Historical Architectural Review Board
COA Preliminary Review Sheet

HDC-2025-00032

Address: 945 Turner Street

Proposal: Legalize stucco on damaged chimney

New stucco (Applicant)

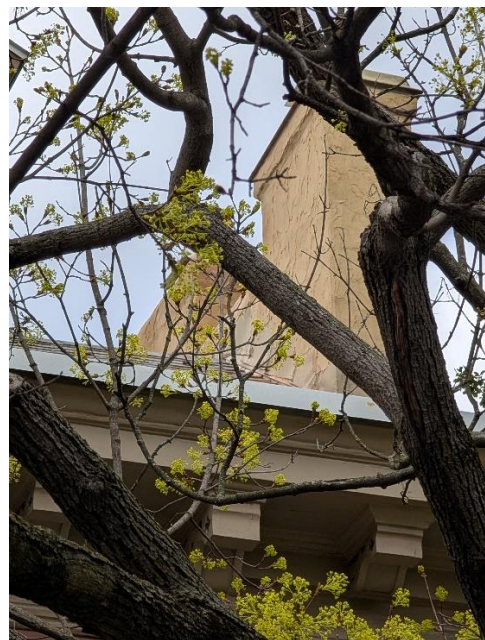
Per Guideline 3.1.27, adding new stucco to historically exposed brick masonry is not appropriate. A more appropriate solution to repair the chimney above the roofline would be to rebuild it, with either salvaged brick from the chimney, or new brick to match the existing in color, size, and profile, and built with mortar to match the existing in color, composition, and tooling. It is appropriate for brick masonry to be unpainted, so while the rest of the building was previously painted, a rebuilt chimney should remain unpainted and uncoated, in keeping with the Guidelines.

Mr. Hammond noted that he would prefer to approve the chimney work, as a reasonable solution for creating a safer building, and Ms. Schreier agreed. Mr. Hart is concerned that approving this repair will set a precedent. Mr. Encelewski noted that the repair is not in keeping with the Guidelines, as adding stucco where it did not exist historically is not appropriate. Mr. Jordan noted that the Guidelines indicate a chimney could be rebuilt in brick, and that the interior work to solve the safety issue is outside of the Guidelines and not under HARB review.

Staff Recommendation: Staff recommend denying.

Mr. Jordan moved to deny the applicant presented on 5/5/2025 for the legalization of chimney work at 935 W. Turner Street as presented, finding noncompliance with Guidelines of Historic Districts: Chapter 3, Section 3.1 Roofs, and found no circumstances unique to the property.
